# STAFF RECOMMENDATION

NCPC File No. 6546

**FORT LESLEY J. McNAIR,**  
NATIONAL DEFENSE UNIVERSITY EXPANSION, PHASE II-  
LINCOLN HALL  
4<sup>th</sup> and P Streets, SW  
Washington, D.C.

Submitted by the Department of the Army

**CROSS SECTION OF ENTRY PORTAL  
'DRUM'**

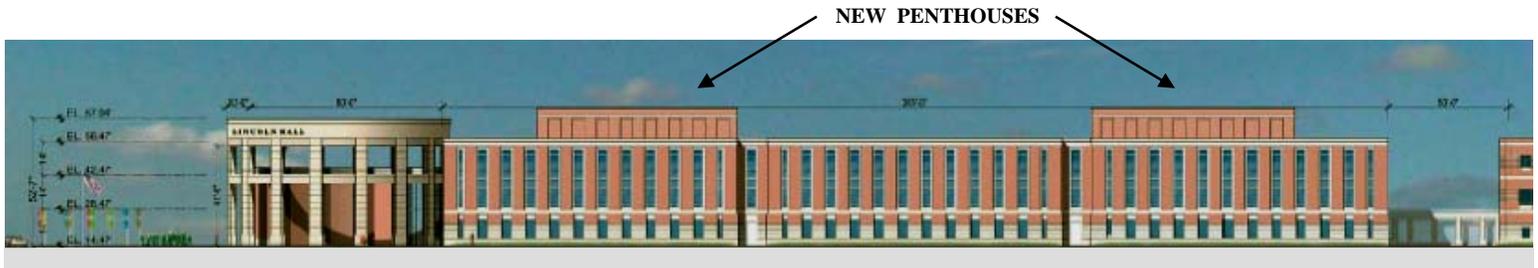
In the final submission, the entry portal has been modified to receive a glass and steel canopy that encloses the top portion of the space. The transparent canopy is not visible from outside the building, but becomes apparent as one enters through the portals into the ceremonial space. The intent of the canopy is to make the ceremonial space weatherized and available during more months of the year for large functions protecting any displays and temporary event items.

The canopy itself is a low profile overlapping glass and steel curving structure that functions with the use of a compression ring and king-pin post. This unique engineering solution allowed a shallow and very narrow framing structure for the design that maximizes the lightness and delicacy of the overhead canopy.
